Project Carlow Library Extension

Report Title Stage 2a Report

Our Ref DI/4502/R1 Issue 1

Report No. DI/4502/R1
Issue No. Issue 1
Issue Date. 08/12/2020

1 PROPOSED FIRST FLOOR PLAN
122 1:100

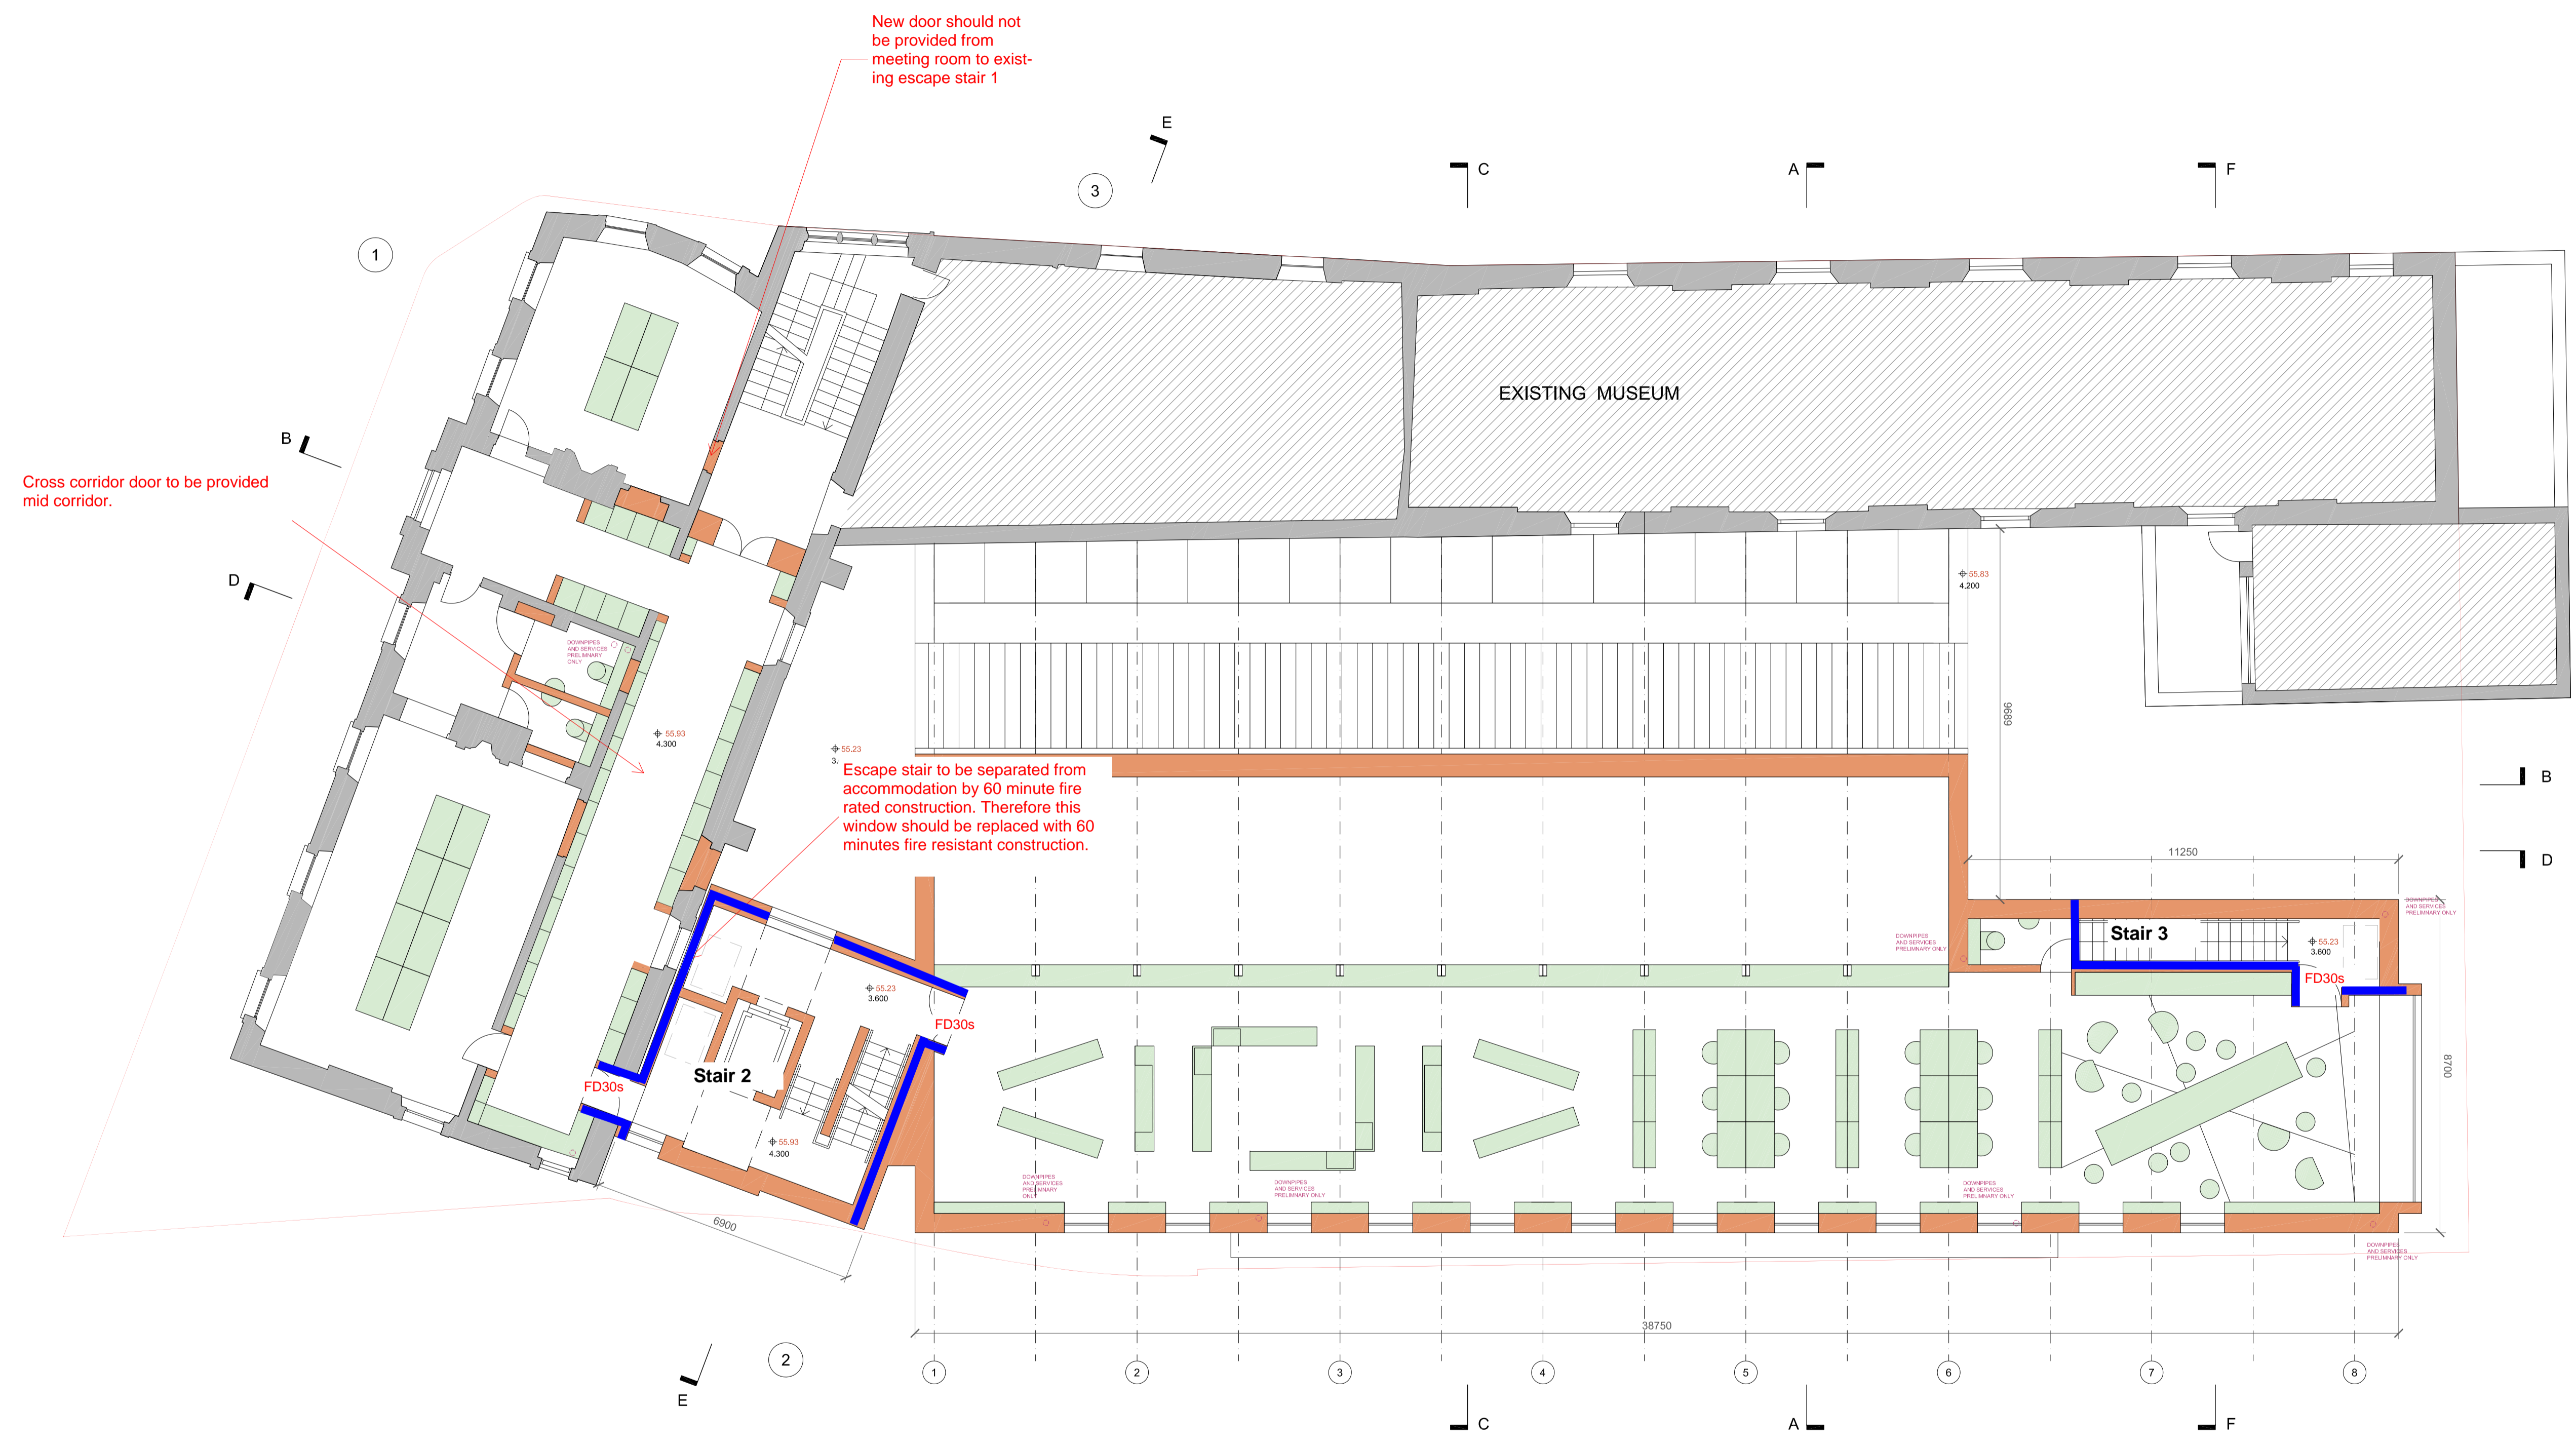
There is to be an open balcony at 1st floor of the new extension, overlooking the ground floor below. Currently there are 2 no. storey exits from the 1st floor (via stairs 2 and 3 respectively). The storey exit into Stair 2 is located adjacent to the balcony and therefore, in accordance with code guidance, may be compromised in the event of fire at ground floor below.

The storey exit into Stair 3 is located at least 5m from the edge of the open balcony and may be reached by occupants without travelling towards the balcony edge (i.e. occupants can travel towards this storey exit along the east elevation of the building). However, the Local Authority Fire Service may consider it more likely that occupants will escape towards the void edge to reach Stair 3, which would not comply with code guidance – this will be subject to Fire Service approval.

Code guidance recommends that escape stairs should not form part of the primary circulation route between different parts of a building at the same level. Currently, Stair 2 forms part of the circulation route between the existing building and new extension at first floor. However, a fire engineering case can be made based on the provision of hold open devices (linked to the fire alarm system) to any fire doors enclosing the stair, which would release to the closed position on activation of the fire detection and alarm system and therefore maintain the fire integrity of the escape stair enclosure. This approach would be subject to Fire Service approval.

Stair 2 is accessed at different levels from the library and from the existing building, therefore, two disabled refuges will be required at first floor level within Stair 2.
